Application of LMPSF Acquisitions, LLC c/o Troutman Pepper Locke, LLP to rezone property from C-2 (General Commercial) zoning district to HR-1 (High Density Residential – 1) zoning district to allow for single-family, attached and multi-family developments, at 3265 Northeast Expressway.

PETITION NO: D2-2025-0628 Z-25-1247529

LOCATION: 3265 Northeast Expressway, Chamblee, Georgia 30341

Site Plan Review (*Illustrative Site Plan - Everstead at Embry Hills, dated 10/17/25*):

OVERALL SITE PLAN

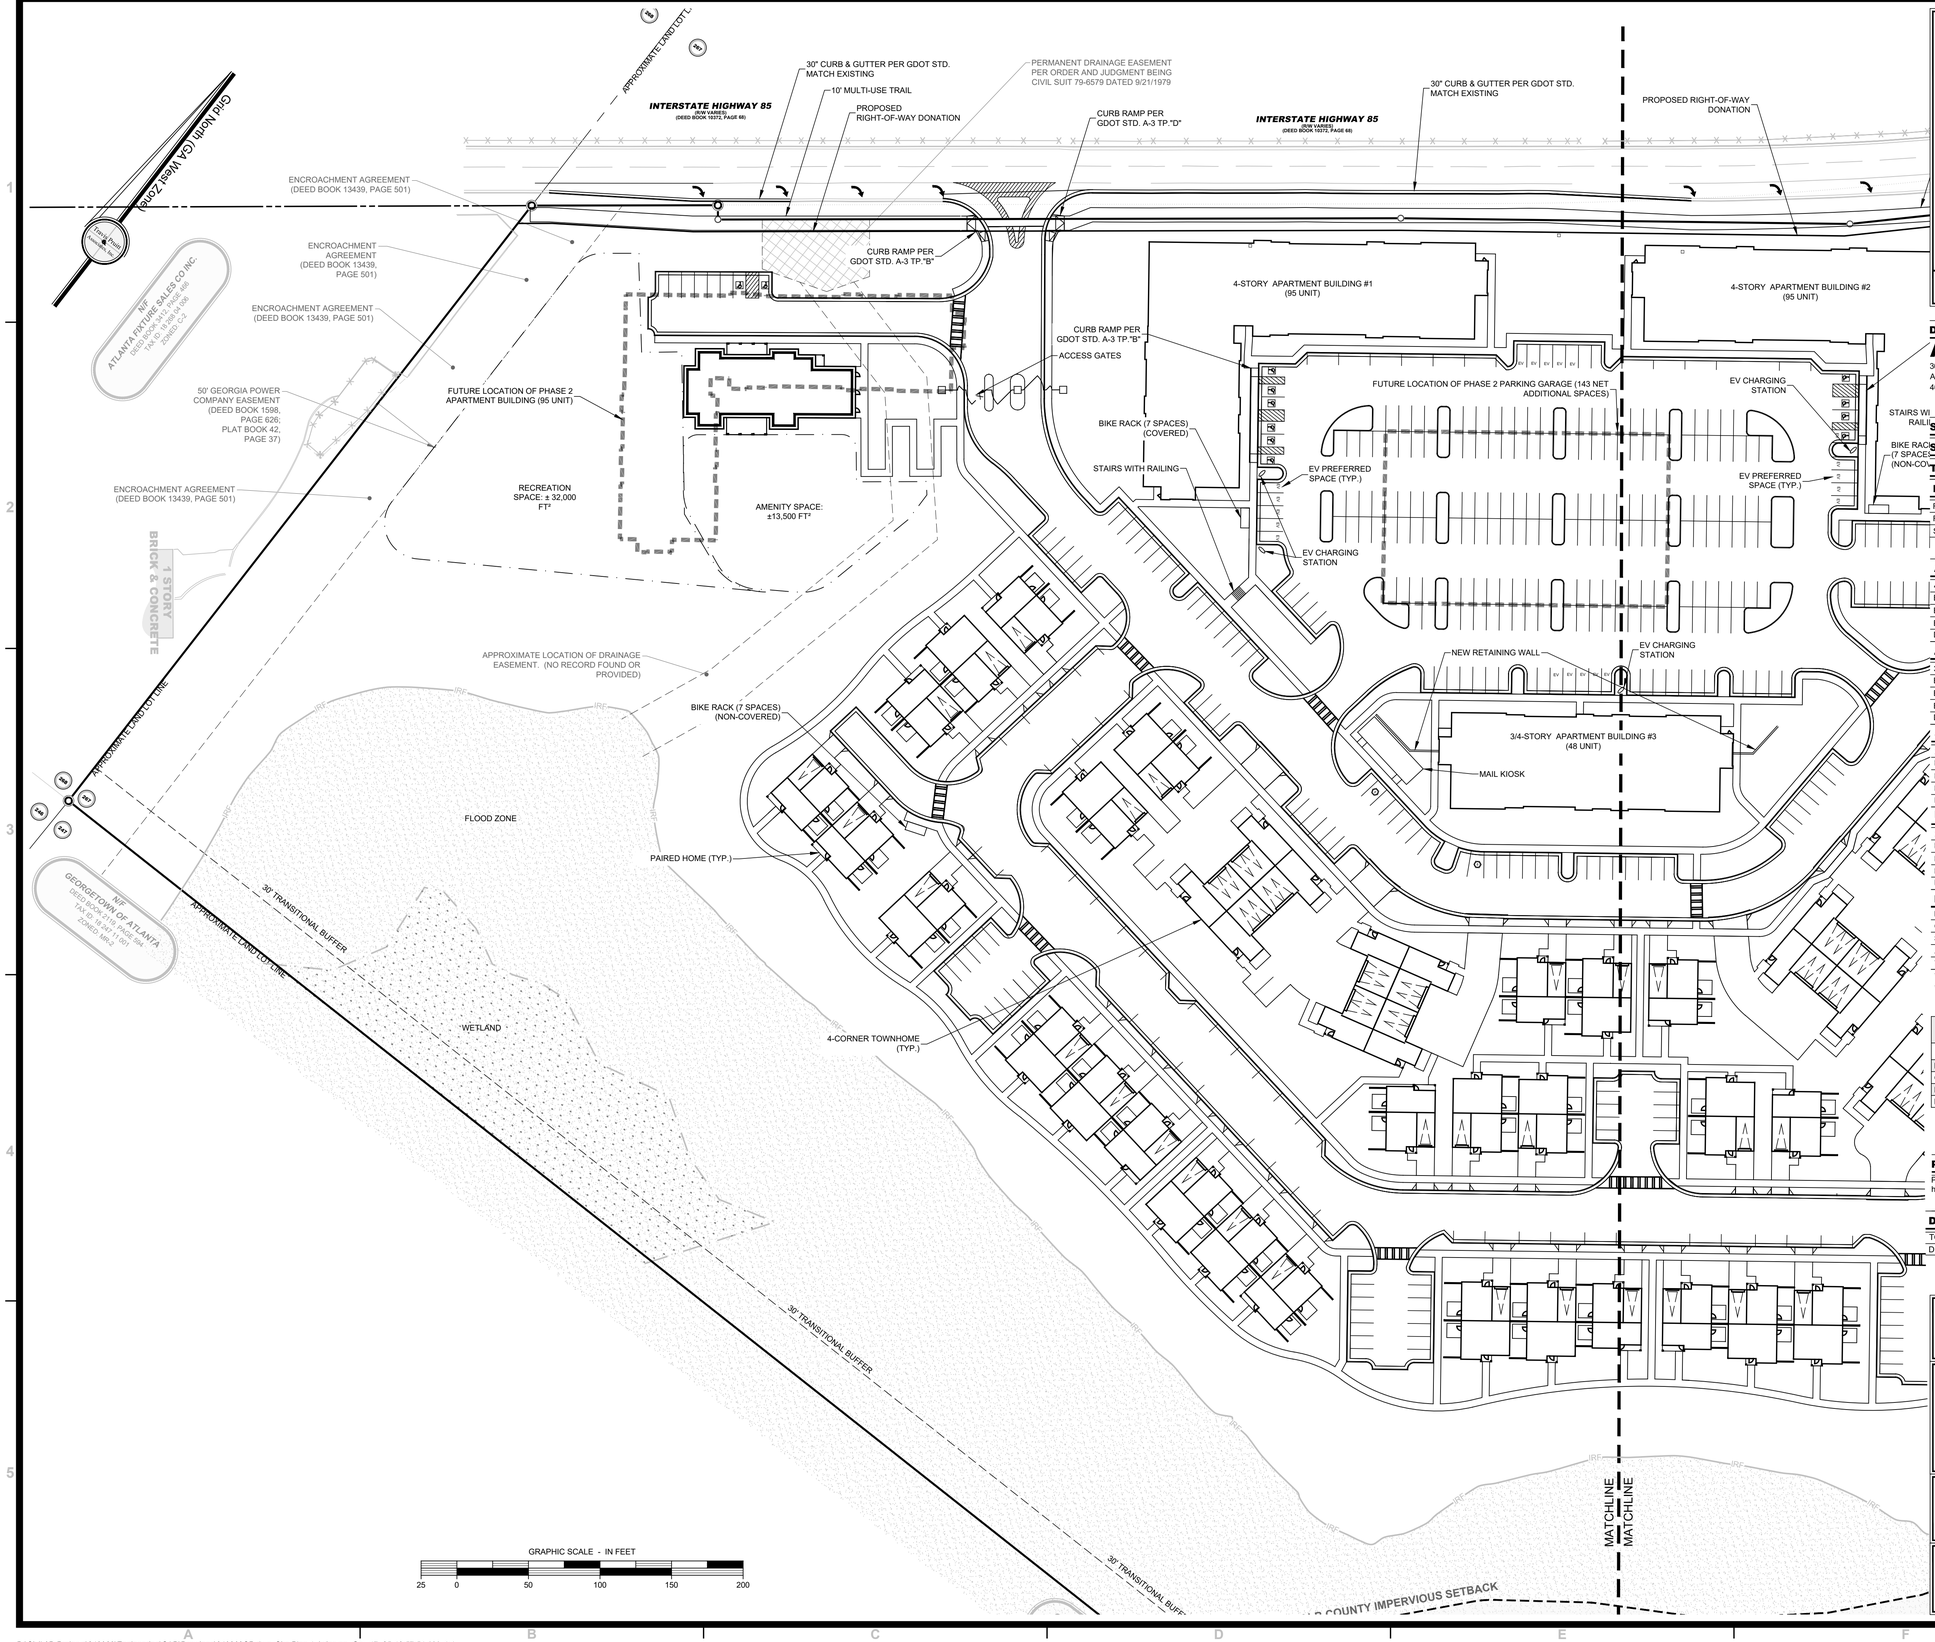
The site plan appears to comply with most of Section *27-2.11.2 – Dimensional Requirements* for HR-1. However, because of the following deficiencies, variances may need to be sought:

- **Interior strips:** Interior to non-residential, mixed-use and multi-family developments, a three-foot (3) wide planted landscape strips shall be required along all interior drives and pedestrian paths per *Section 5.4.4 - Site and Parking Area Landscaping B.* As well as *D. Parking Area Landscaping* tree *and island quantity (4 and 5).*
